## **TRANSMITTAL MEMORANDUM 99-03**

**DATE:** August 30, 1999

**SUBJECT:** Structure Plans

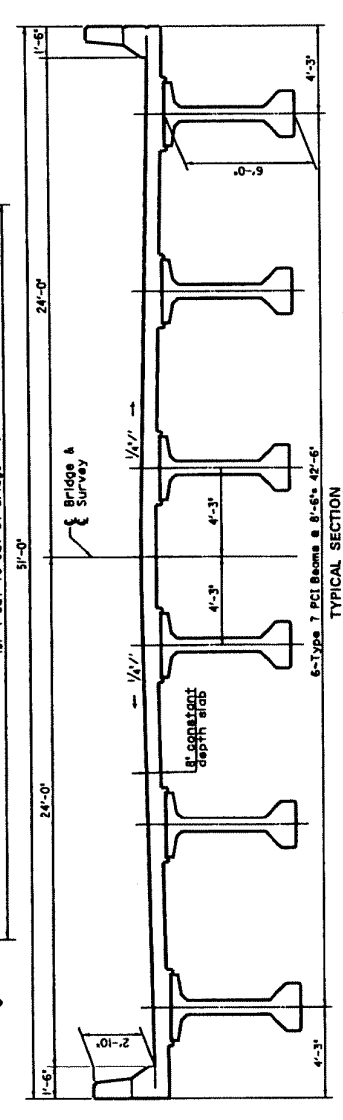
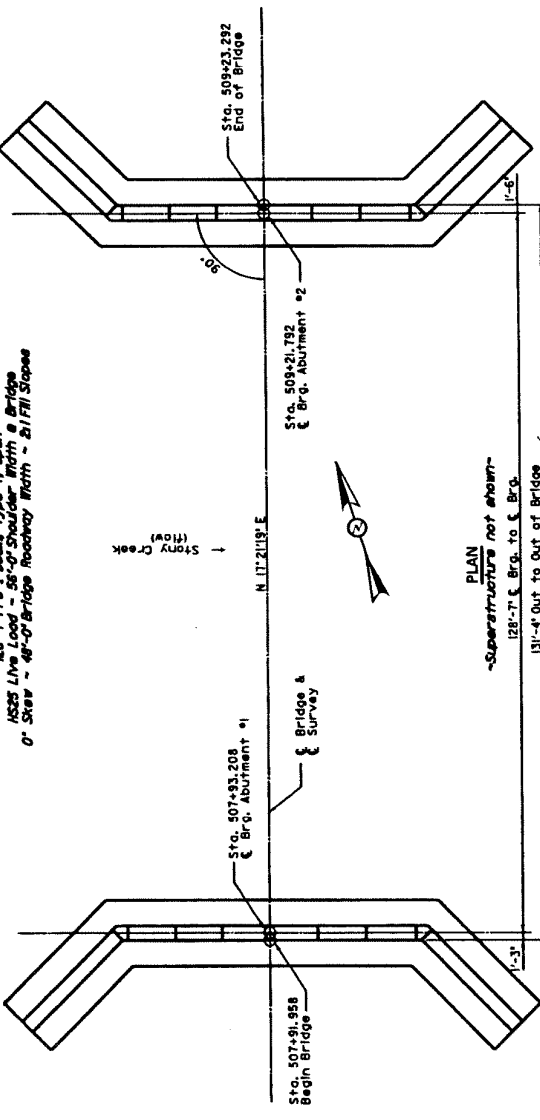
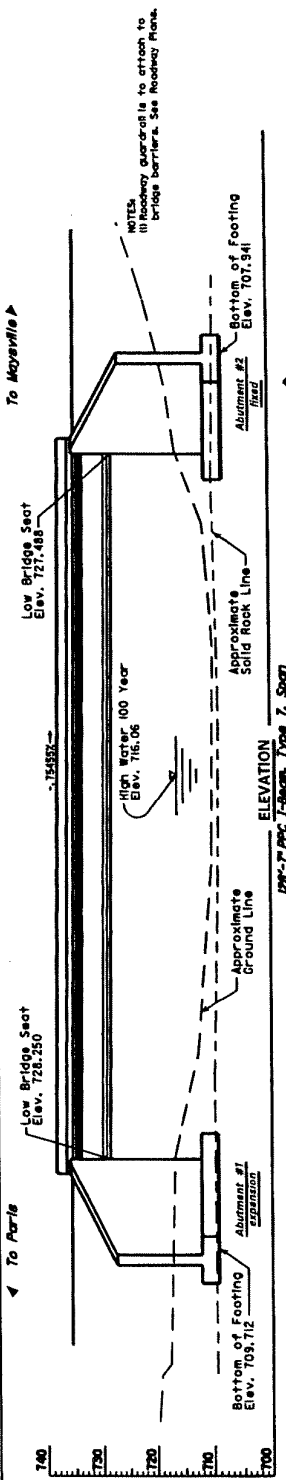
Of note, the following changes will be incorporated into the English Standard Drawings:

- a) Major changes to the barrier and transitions - The barrier will be 1 foot 6 inches wide and there will be no turnback on the transitions.
- b) Box beams have been redesigned and the span lengths are in 2 foot increments. The curb has been reshaped to match roadway drainage curbs, thus reducing the size of the curbs.

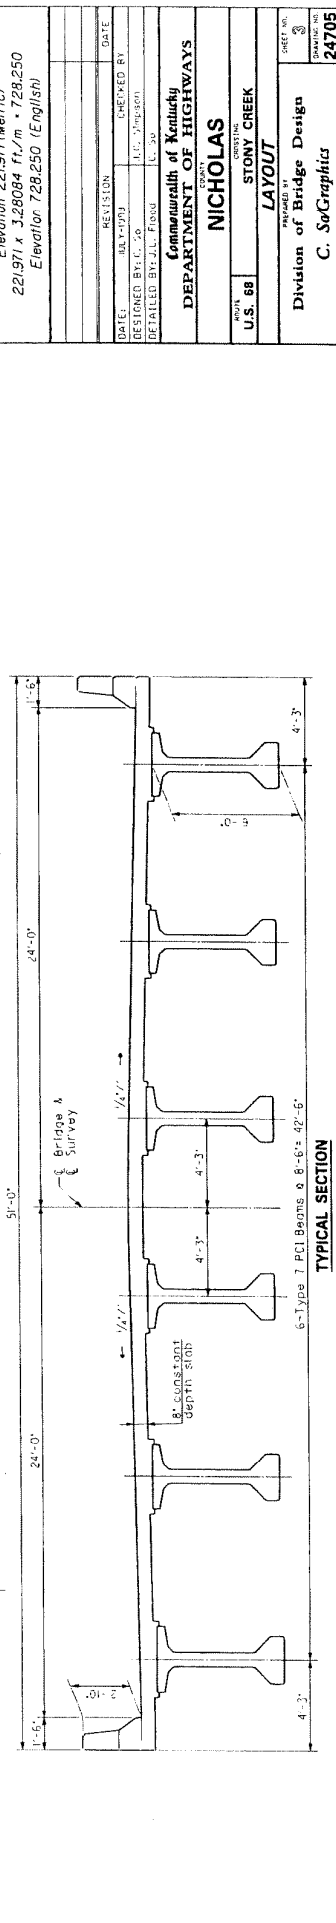
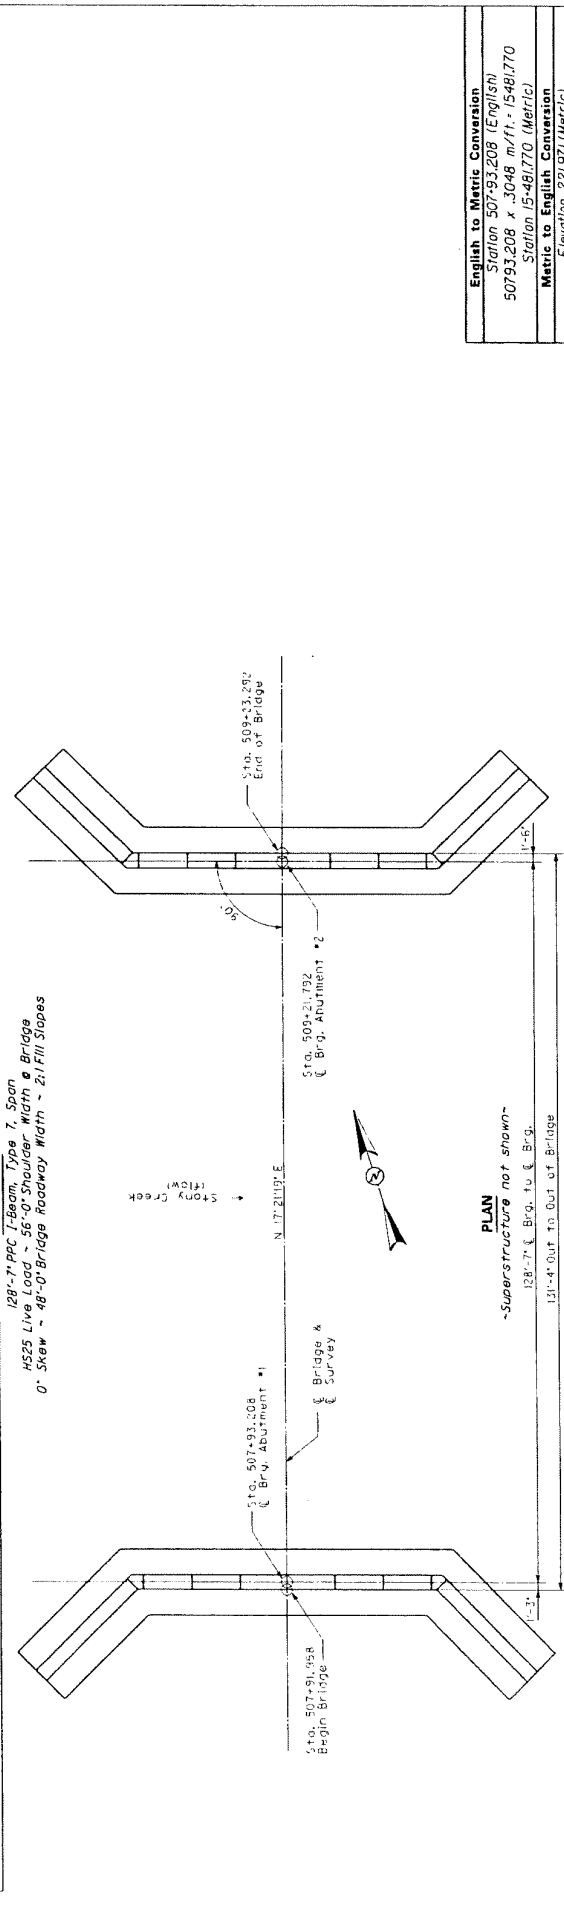
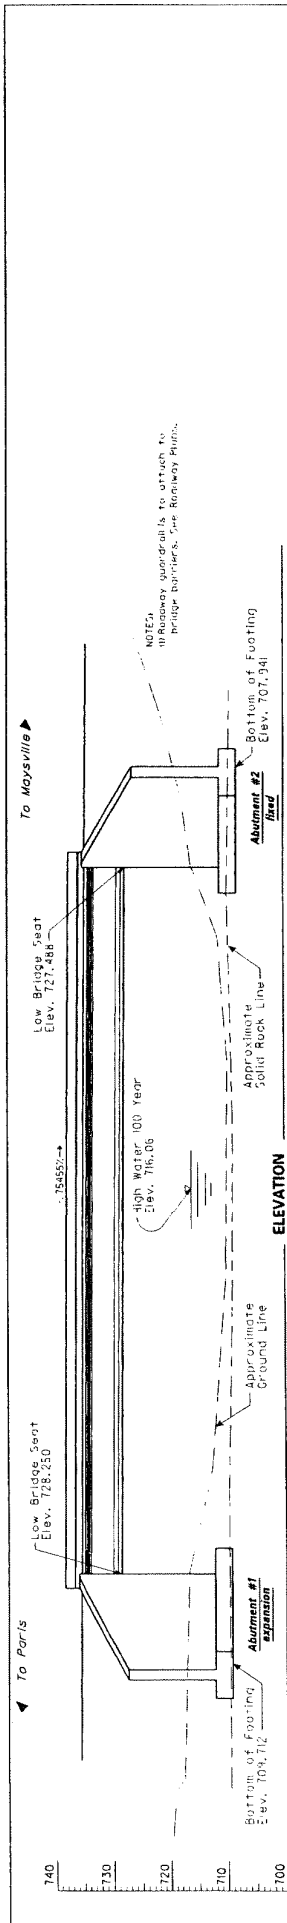
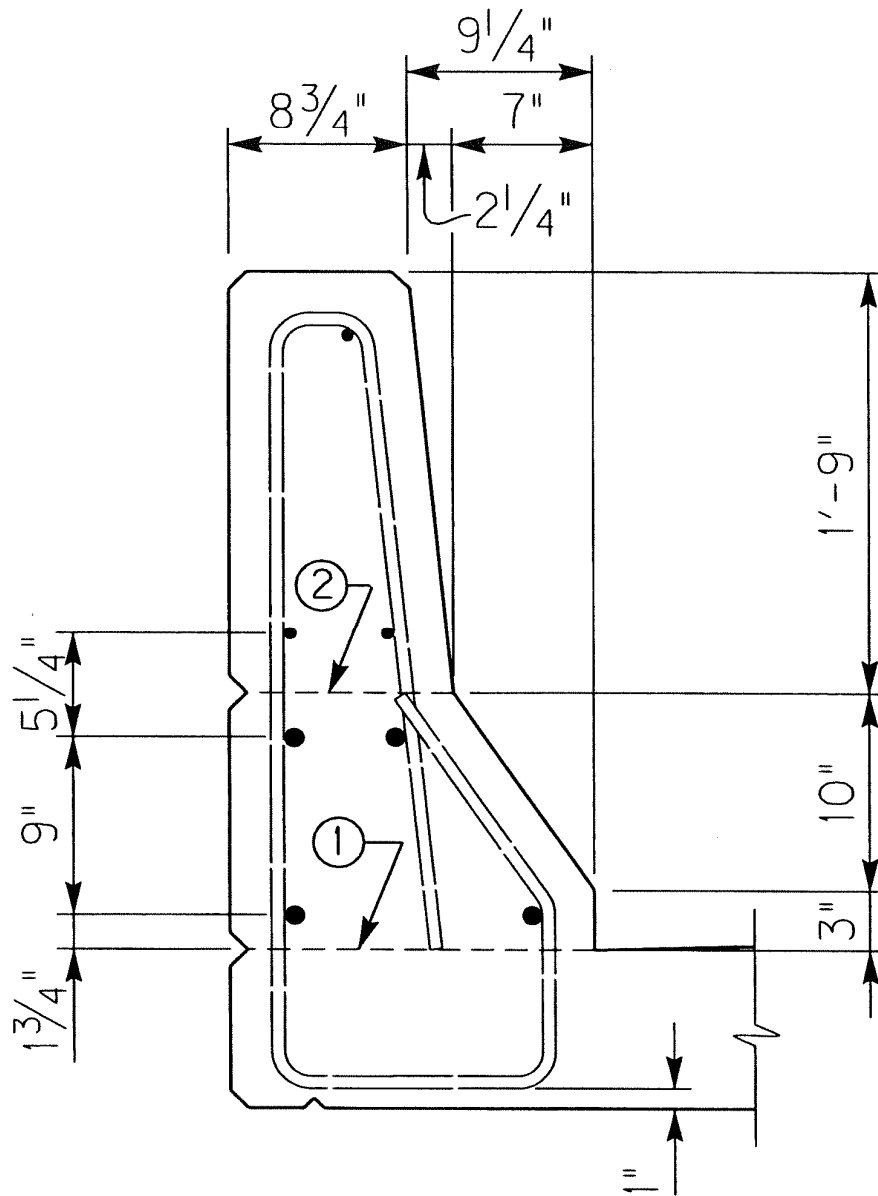
When roadway plans are in Metric Units, the stationing for the structures shall be in equivalent English Units. A note (placed on the layout sheet) shall provide an equation to indicate corresponding Metric stations and elevation. An example layout is attached. The designer is encouraged to adjust span lengths to even inches.
